RADIO TRANSMITTER MODELS GPT-750F-2, GPT-750G-2 AND GPT-750H-2

INSTRUCTION BOOK CHANGE NOTICE

Manual affected: <u>Technical Manual for Radio Transmitter</u>, IN <u>-313</u>
Model GPT-750B2

Figure 1

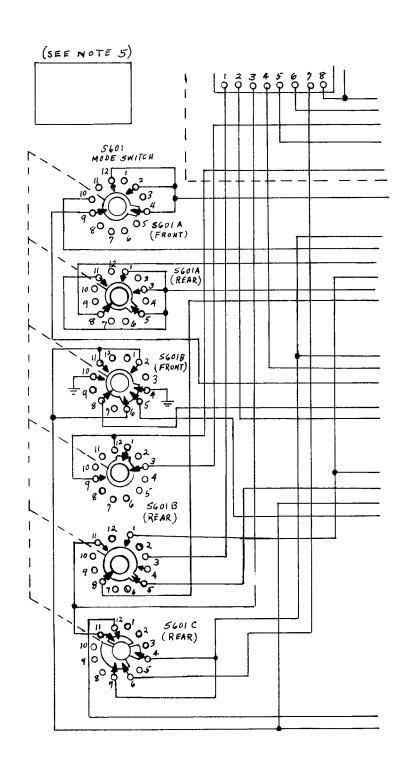
- 1. Change paragraph 6-3c, on pages 6-5 and 6-6, as follows:
 - a. Step 1, from: "... indicator reads 2000 kc., "to: "... indicator reads 1900 kc."
 - b. CAUTION, step 6 from: "2000.000 kc." to: "1900.000 kc." The error is in two places; correct both.
- 2. Change figure 6-9, pages 6-19/6-20, as follows:
 - a. Neatly cut out figure 1 (attached to this change notice) and appropriately affix it to figure 6-9 in the manual.
 - b. Add the following as NOTE 5: UNLESS OTHERWISE SPECIFIED, ALL IDENTICALLY NUMBERED FRONT AND REAR TERMINALS ON SECTION A, OR SECTION B, OR SECTION C OF SWITCH S601 ARE ELECTRICALLY CONNECTED.
 - c. Reverse diodes CR601 and CR602; they are drawn backwards.
- 3. Change the parts list, page 7-19, as follows:
